Solicitation Addendum

Solicitation No.: 23-R080576JH

Solicitation Title: Jiggs Landing Boardwalk Repair 2023

Addendum Date: December 28, 2022

Task boundaries

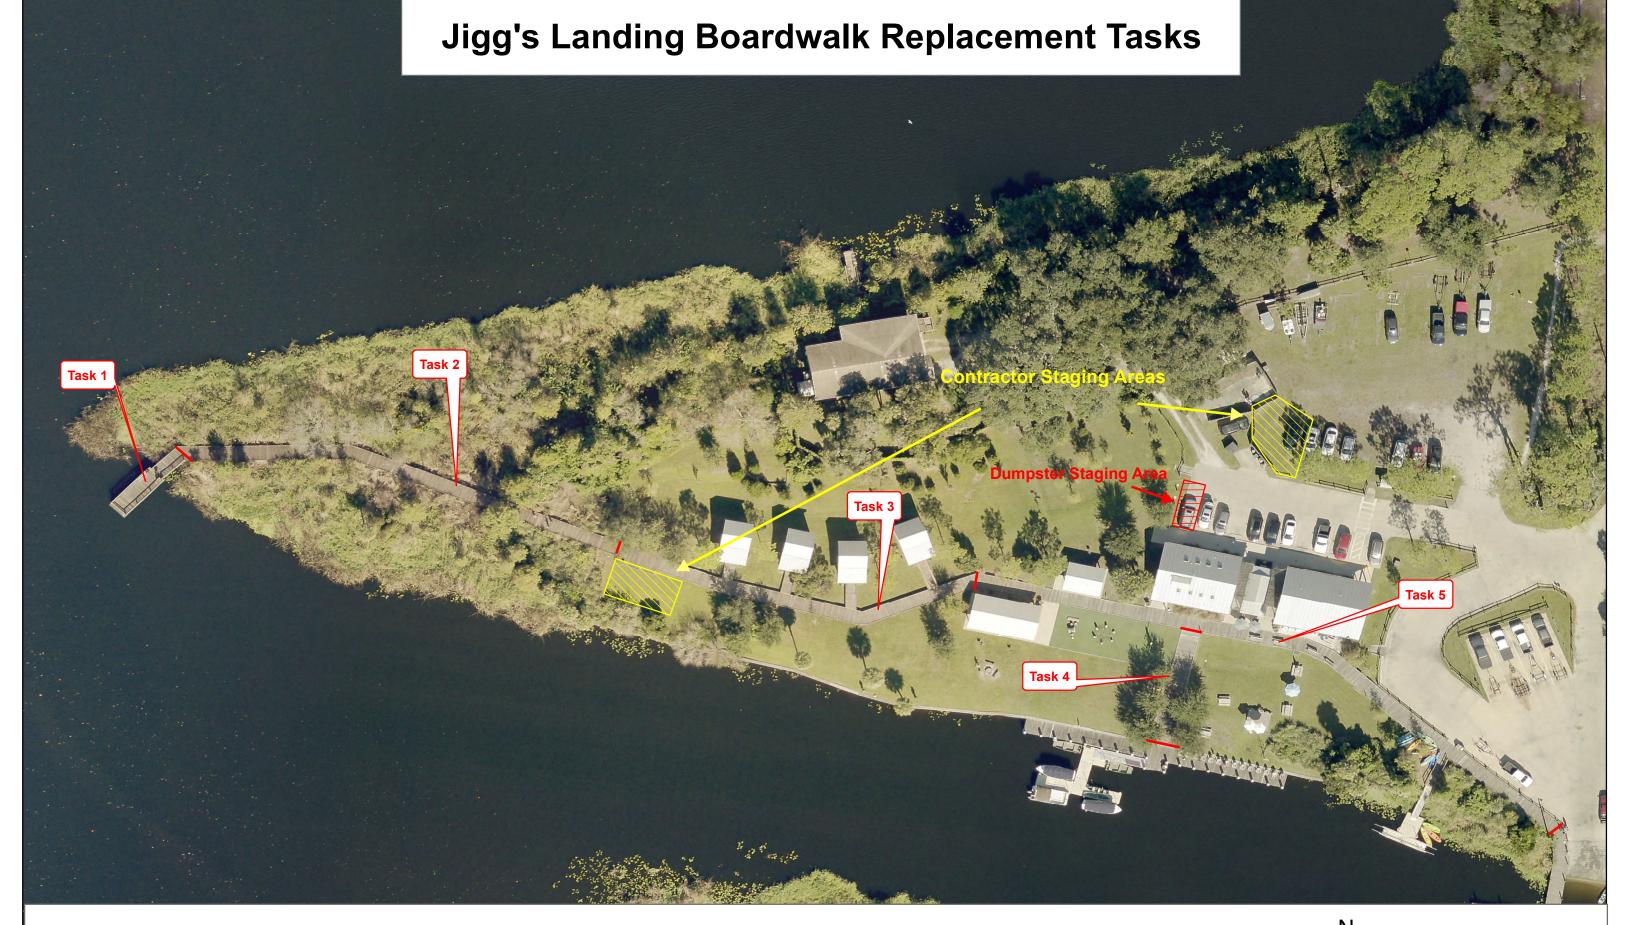
- Q1. Page 34, 1.04 B. Task 2 gives an approximate boardwalk length of 165' however, when referring to the map on page 39 and measuring that distance, it appears to be closer to 245'. Please clarify?

- Q2. Will the contractor be allowed to use any area onsite as a laydown and staging area?
- R2. Yes, please see Exhibit 3, Site Map Revised, and issued with this Addendum 1 which now depicts "Contractor Staging Areas". These will be usable throughout the duration of the project and must be vacated and returned to previous condition before final invoices have been paid.

- Q3. Can a dumpster be placed in the parking lot close to task 5 boat ramp area?
- R3. Yes, please see Exhibit 3, Site Map Revised, and issued with this Addendum 1 which now depicts "Dumpster Staging Area".

- R1. The GIS measurement shows 243.3'. This is a mistake in the scope of work. Please use the 245' figure as an approximate measure of the length for this section of boardwalk (Task 2).
